**Review and Evaluation of:
A Site Assessment Report For
Kentucky Pioneer Energy
Case Number 2002-00312**

Report Date: January 28, 2003

Kentucky State Board on Electrical Generation and Transmission Siting
211 Sower Boulevard
P.O. Box 615
Frankfort, Kentucky 40602

Jason Associates Corporation
808 Kalmia Hill Road
Aiken, South Carolina 29801
(803) 642-2304 ? (803) 642-2305 (facsimile)
<http://www.jason.com>
jrivers@jason.com

Figure C-1. Proposed Site Layout

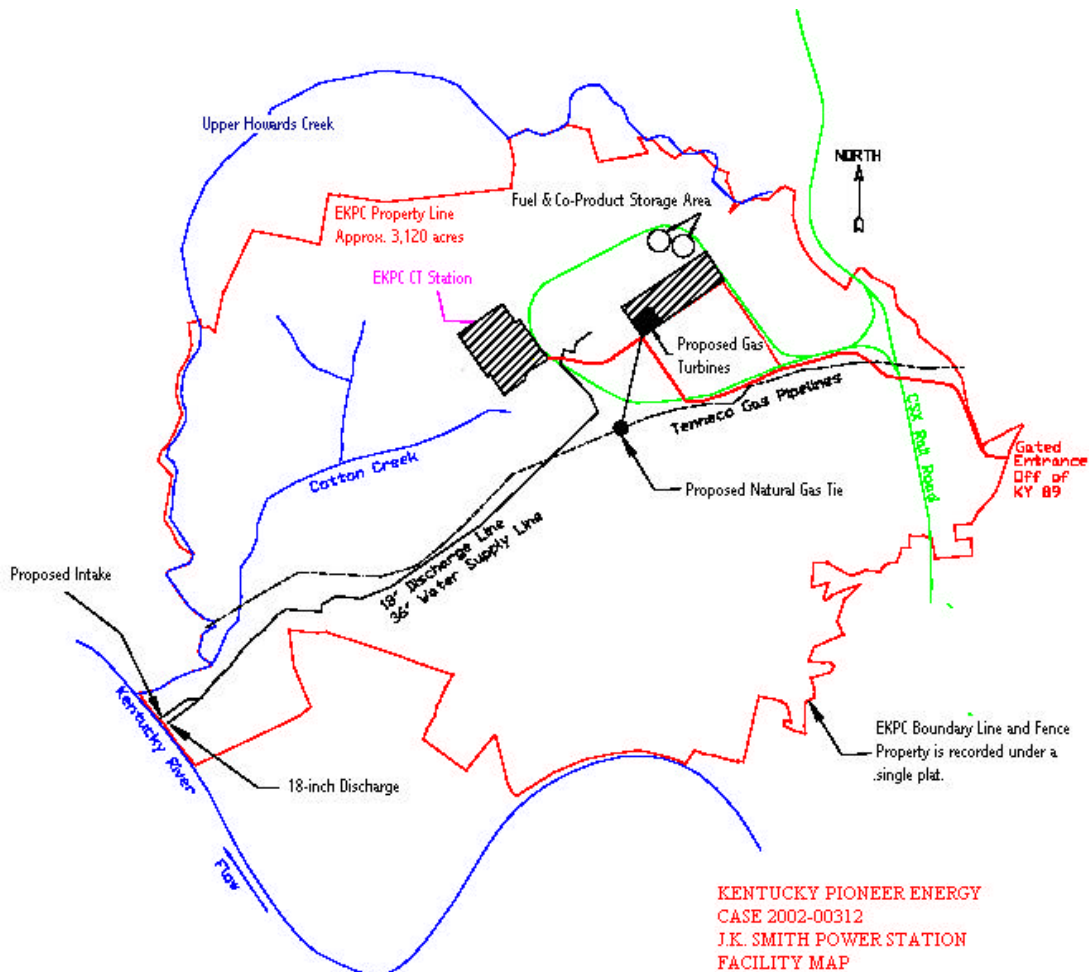
The Site Development Plan (SDP) states that there is no surveyed delineation of the KPE lease site. Rather, the lease generally identifies the rail loop, other areas, and certain buildings for joint and cooperative use.⁴ Figure C-1 provides an illustration of the site layout and relative locations of the KPE project and the EKPC site boundary.

Natural gas service will be required for startup of the facility. Natural gas pipelines from Tenneco currently traverse the site and are used by EKPC at their J.K. Smith site. KPE has stated that they expect to tie into an existing transmission line within the EKPC site boundary. Initial discussions regarding the tie-in have begun, but a specific tie-in location has not yet been identified. KPE provided a proposed tie-in location on their site layout provided earlier as Figure C-1.⁷
